MARTIN RIVER  
BRIDGE

REFERENCE MILE 308 MACKENZIE HIGHWAY

DEPARTMENT OF PUBLIC WORKS  
EDMONTON, CANADA

BASIC ENVIRONMENTAL DATA  
MARTIN RIVER BRIDGE  
REFERENCE MILE 308

MACKENZIE HIGHWAY  
MARTIN RIVER BRIDGE  
REFERENCE MILE 308

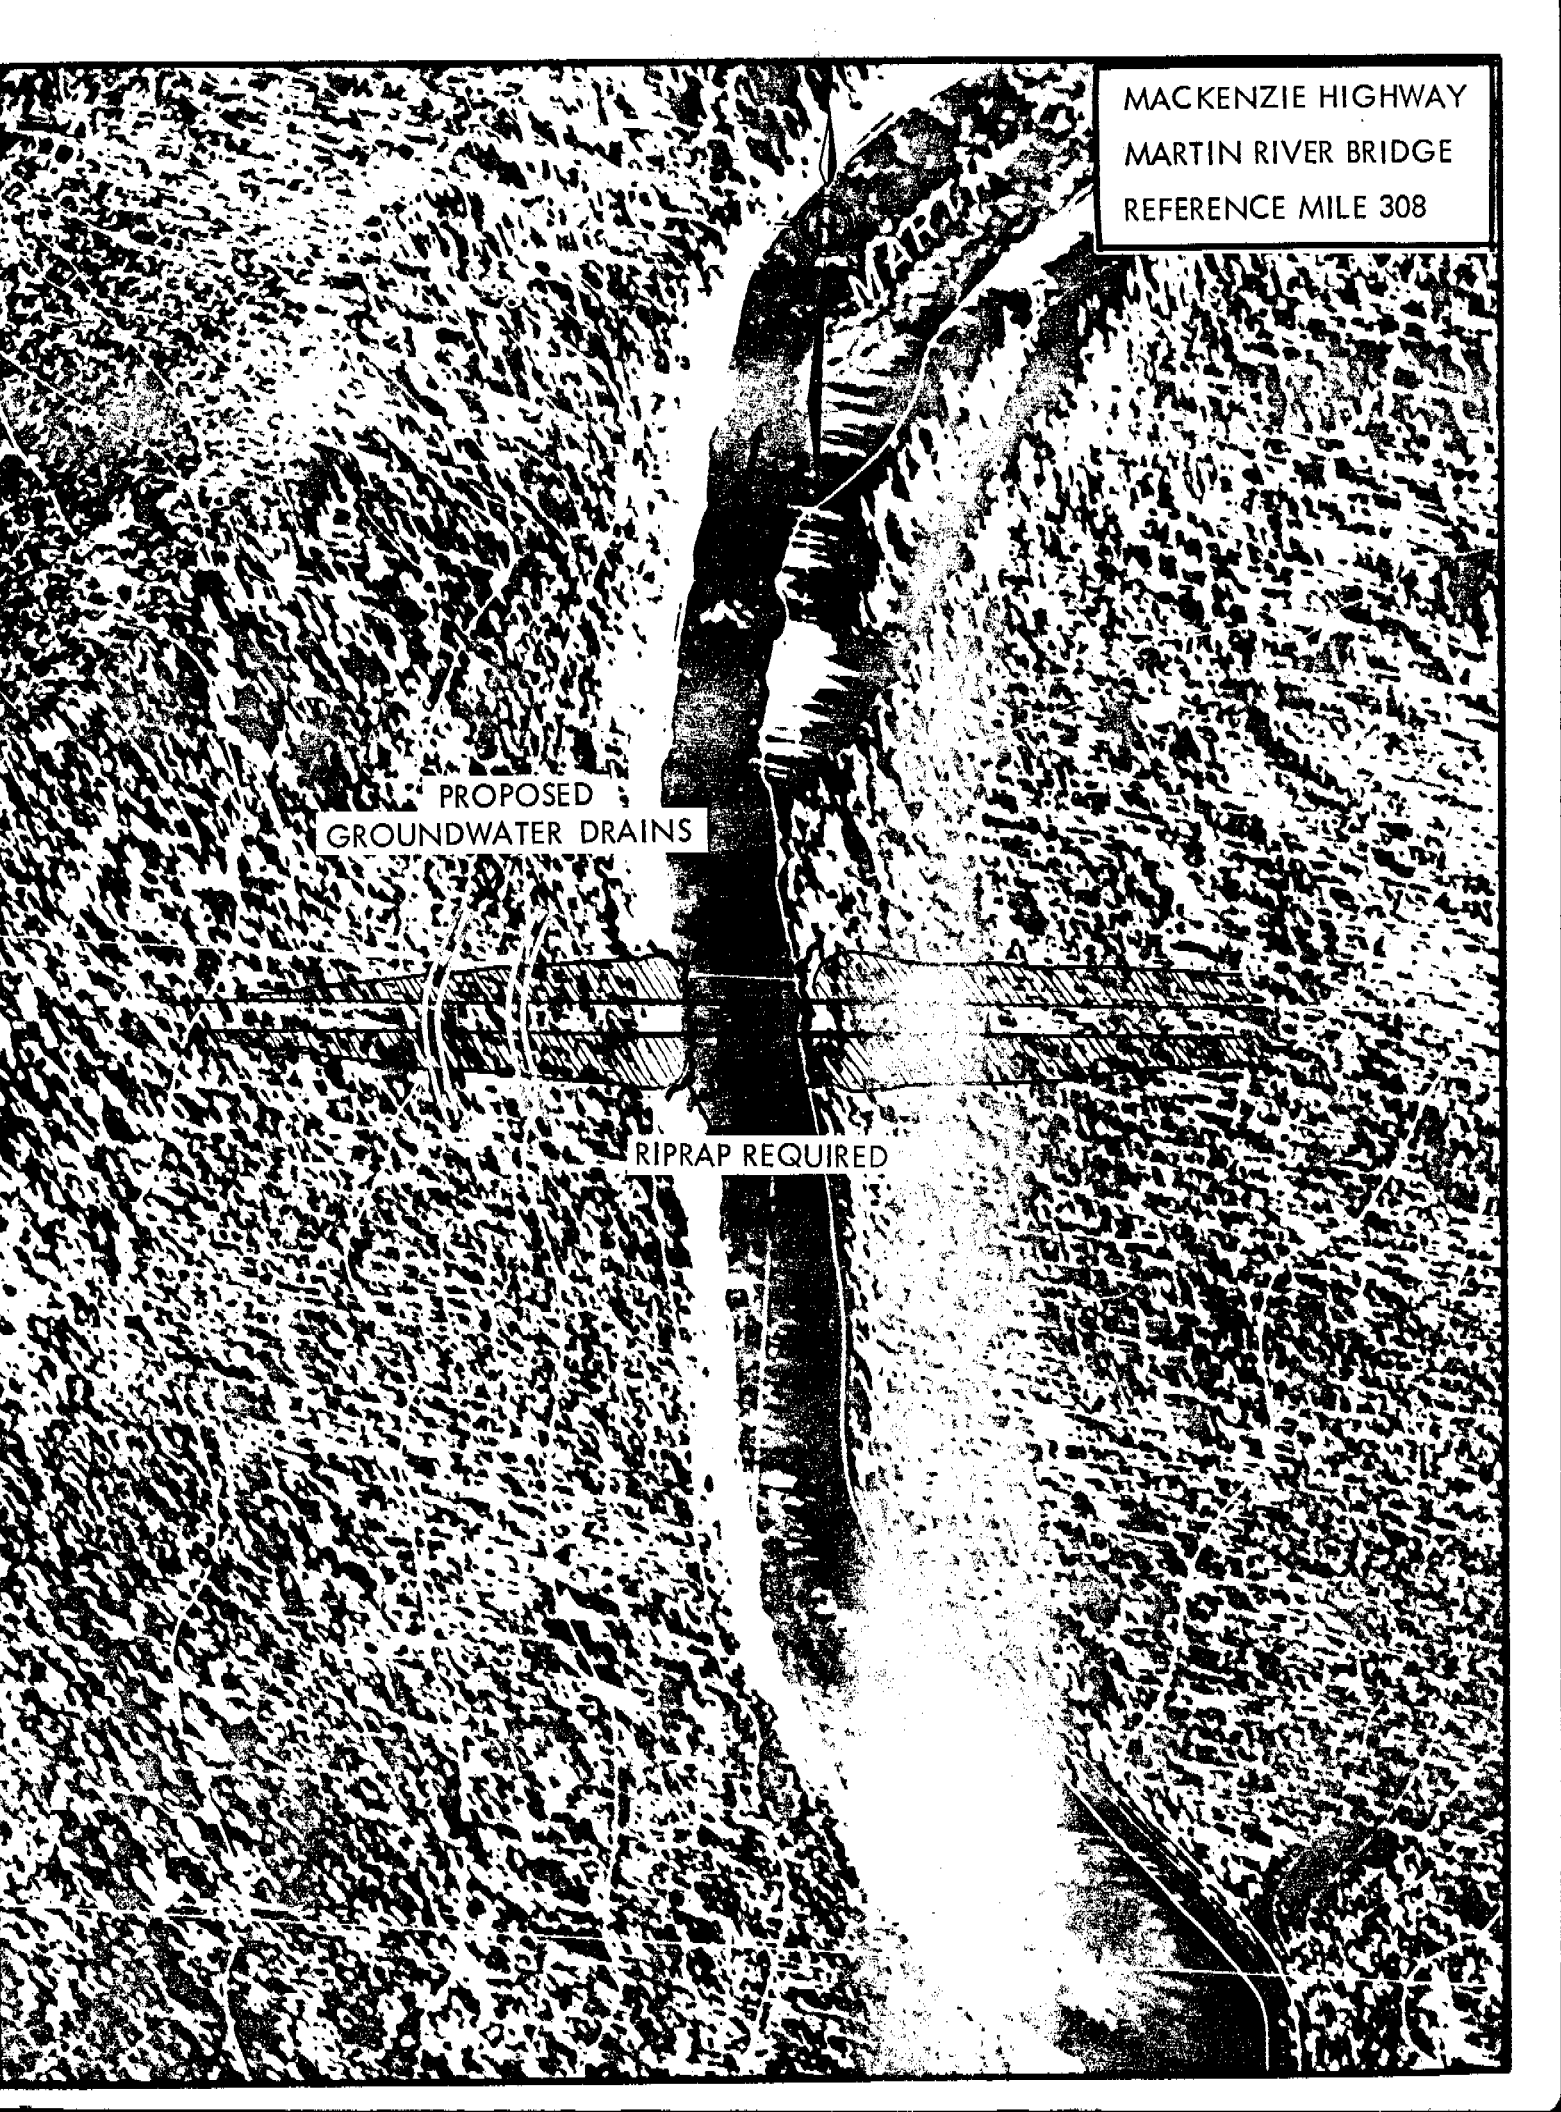
PROPOSED  
GROUNDWATER DRAINS

RIPRAP REQUIRED

The west side requires cut and fill. It is recommended that fill be placed immediately and in stages to establish frost penetration since this slope is highly susceptible to shallow solifluction flowage and possibly more extensive mass movement if preventative measures are not implemented before thaw in 1973. Fill material is readily available from sand dunes that occur in the area. If dune sand is used it must be protected from rill and gully erosion. Cut area should be treated as previously recommended, i.e., vertical cuts insulated and back-filled with coarse granular fill. Also, two sub-surface drains should be constructed to accommodate possible ground-water seepage.

Riprap is required at the base of footings and fill. The bridge design should be modified to minimize encroachment on active channel and remove footings from active channel. This is particularly relevant to the east footing of proposed bridge.

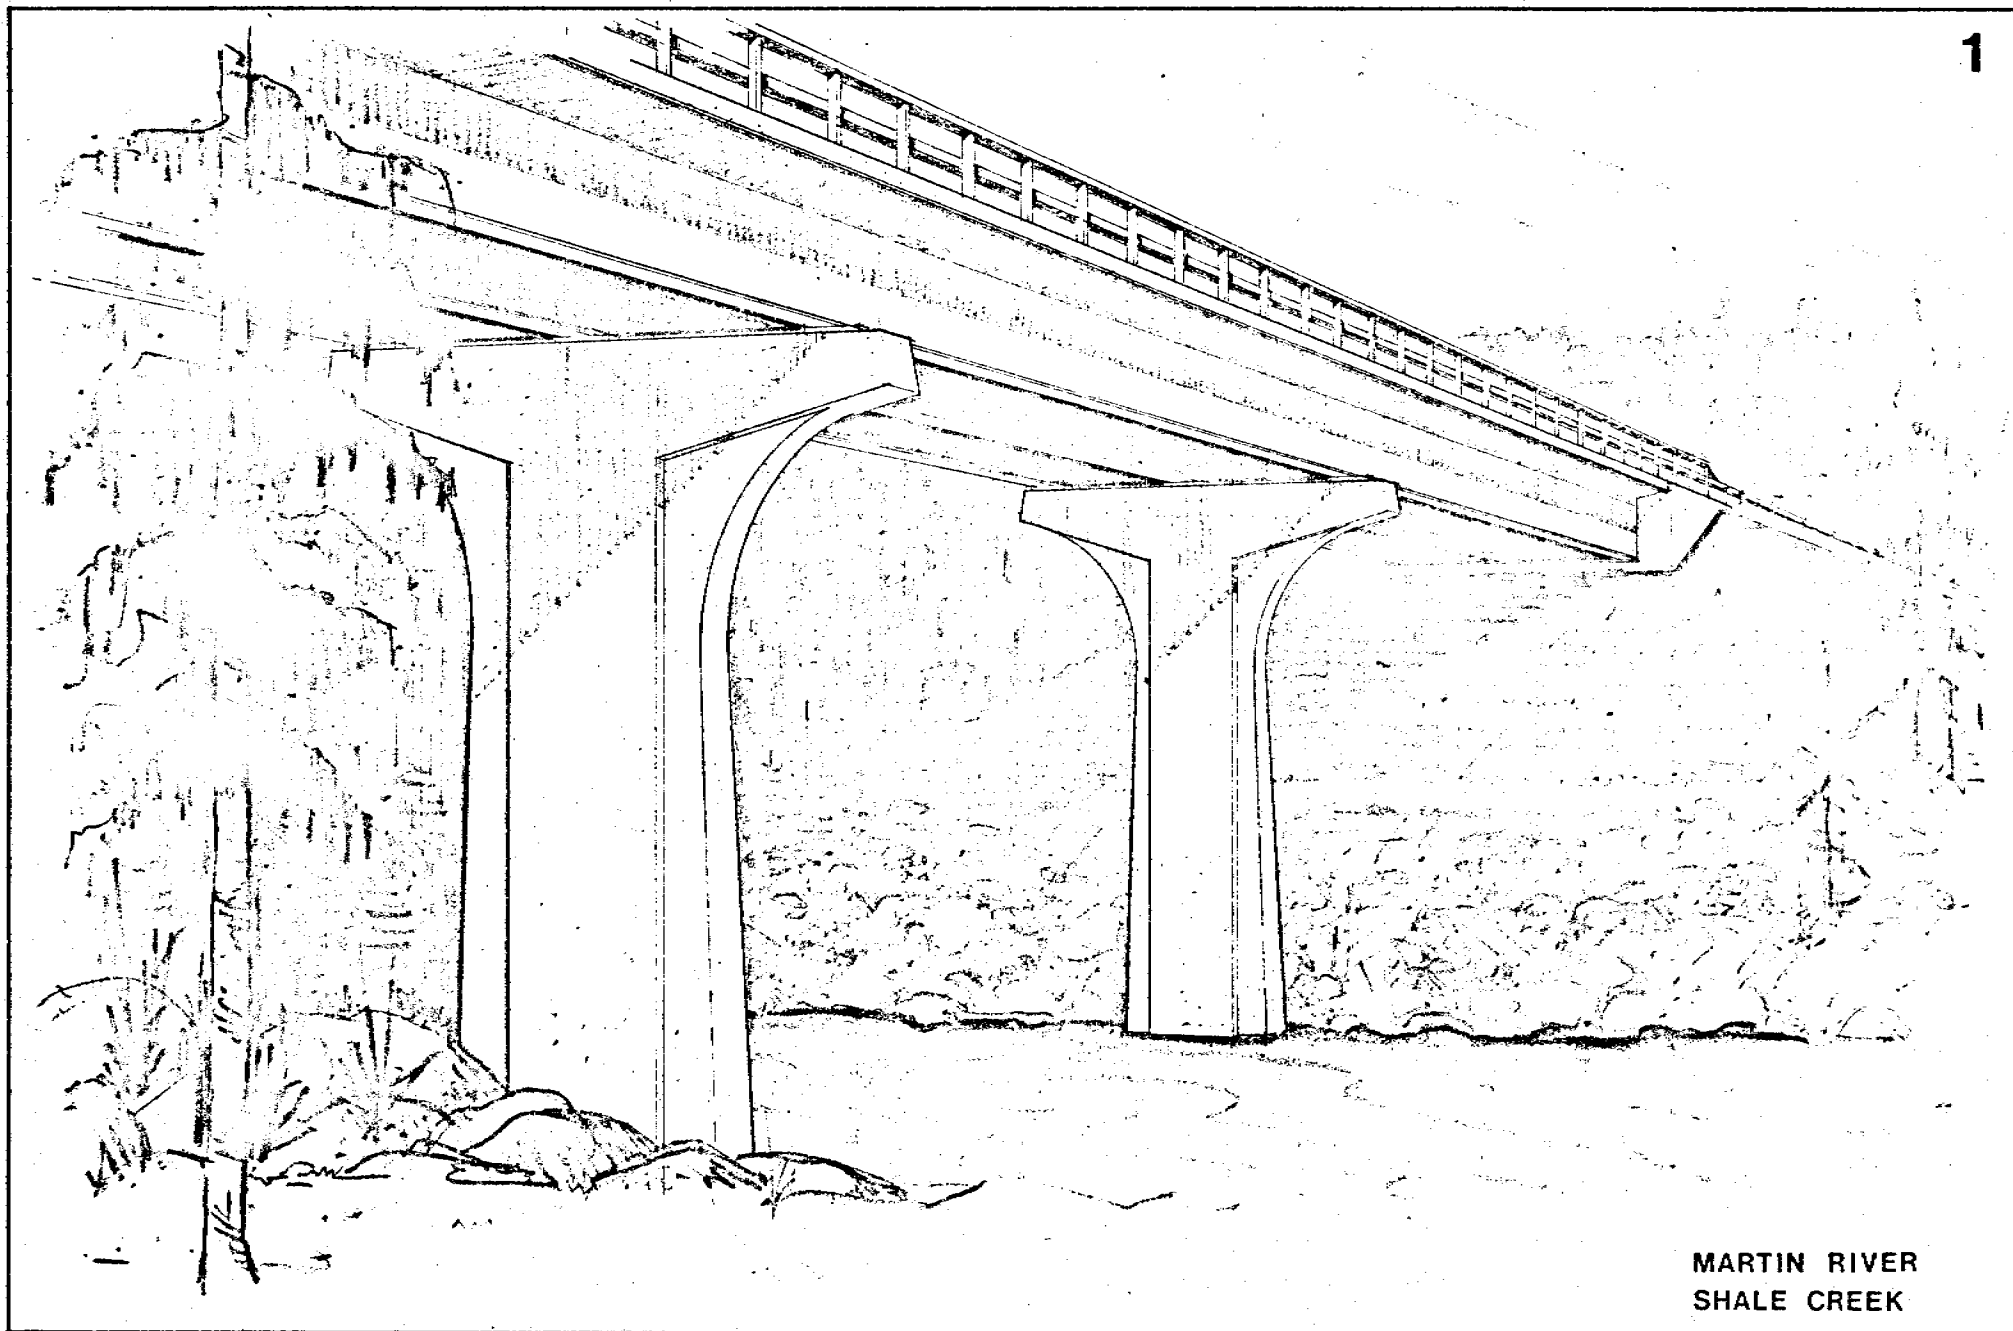
16.9.72. East bank of the Martin River. Vegetation is mainly black spruce with some aspen on peaty gleysol soils. Landform is an abandoned alluvial terrace mantled by silt and sand which is overlain by organic material. The upper 10 feet is believed to contain abundant ground ice, this is partly manifested by pools of water along R.O.W. as shown in photo.

16.9.72. East bank is on the left, stream channel is straight at site; erosion and deposition appears equal on each side of stream. Bridge footings should be located above High Water and Ice Level. Rip-rap at base of footing and along base of fill will be required.

#### 7.10.72. Martin River

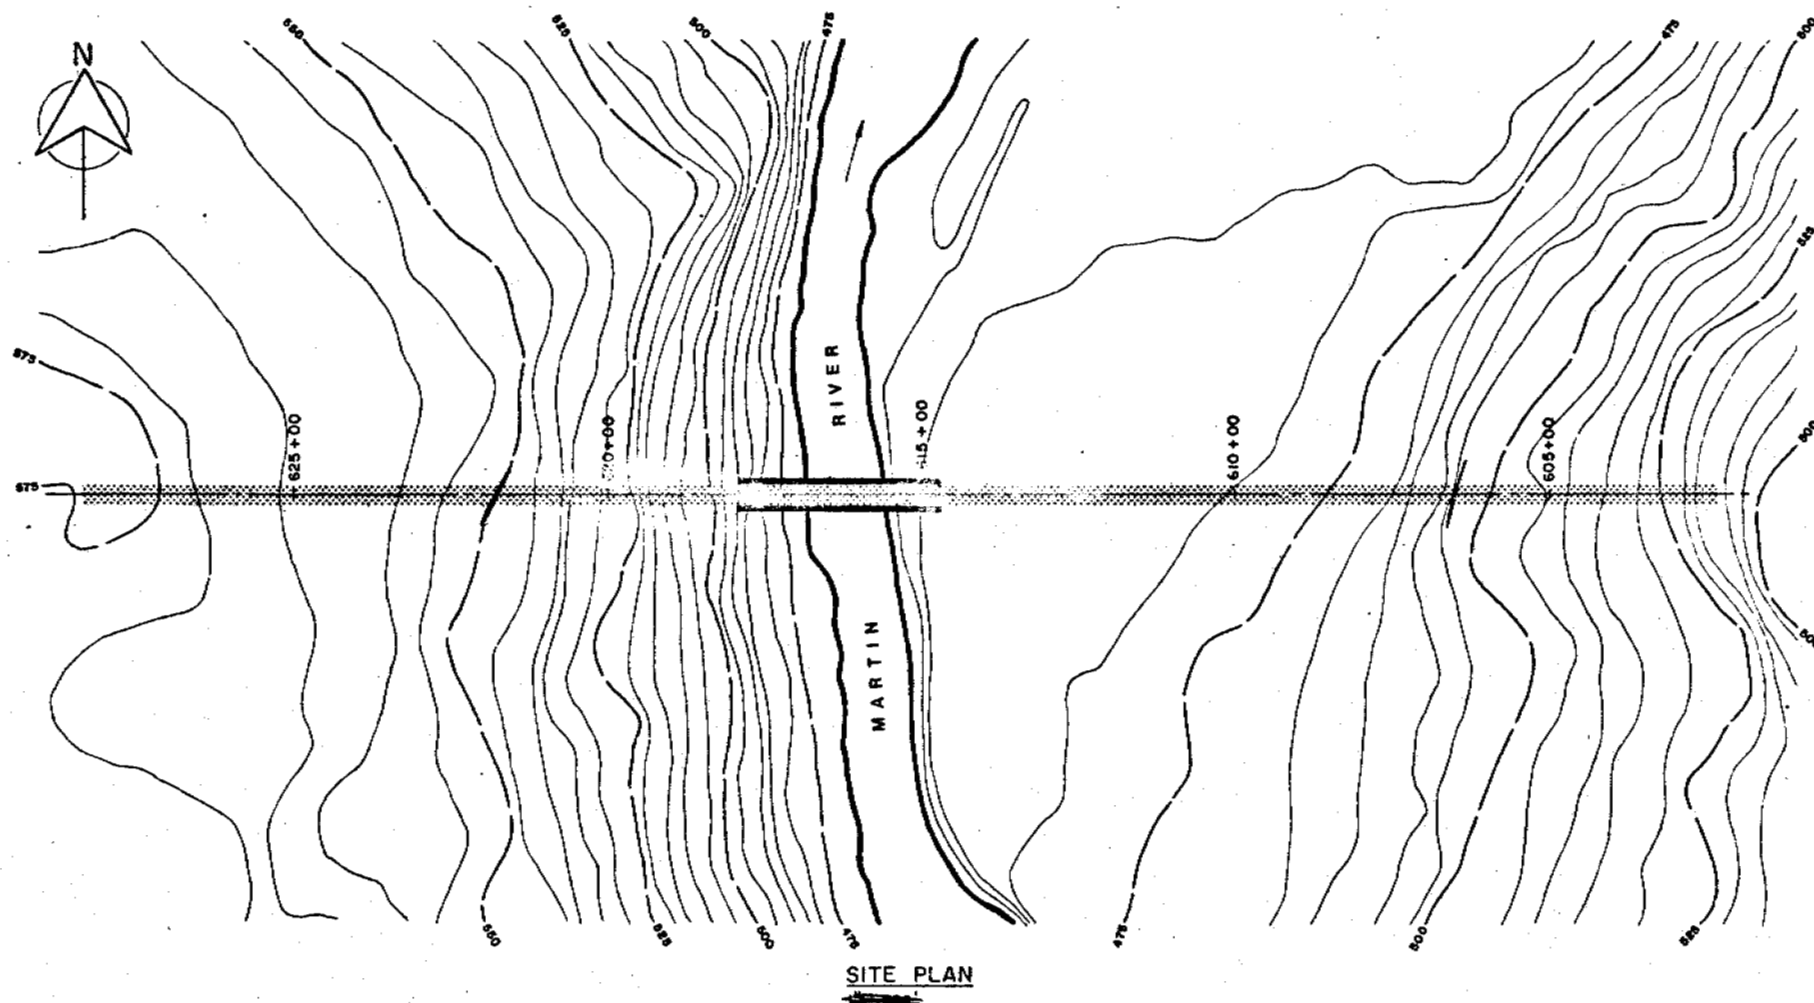
Exposed bank is subject to surface solifluction. The arrow shows an area stabilized temporarily with tree limbs and tops. The slope is underlain by glaciolacustrine silt, clay and sand with possible high ice content. Further thermal erosion may result in extensive degradation. Fill should be placed immediately in layers two to three feet thick allowing time for frost penetration between applications. Slope must be treated with adequate drains to intercept groundwater seepage. Fisheries personnel have sampled aquatic insect populations both above and below the crossing site.

PROFILE  
 VERT. 1" = 20'  
 HORIZ. 1" = 200'

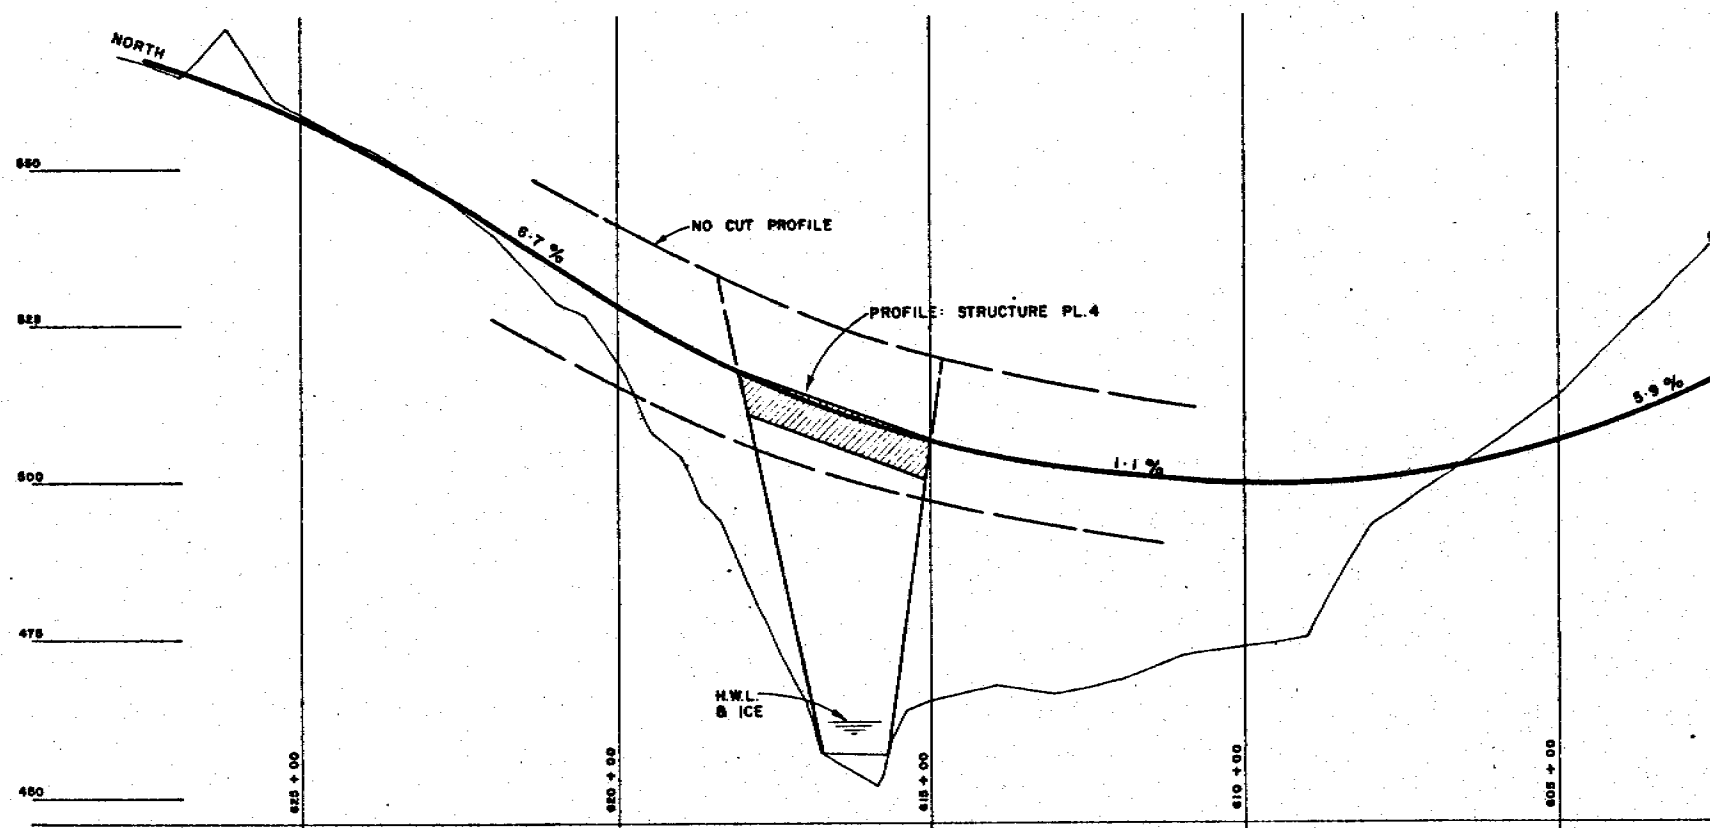
The most serious hazard to the aquatic environment by the proposed bridge design is the proposed placement of piers at the water's edge. If steel cofferdams are used siltation will be greatly reduced. If the piers were situated at least above the low water levels of the stream, impact would be further reduced.

The proposed bridge design offers no particular visual interest. The use of a longer span and subsequent smaller piers would be a decided aesthetic improvement.

The bridge's main span should be lengthened to remove piers from the active channel for fishery and aesthetic improvement.
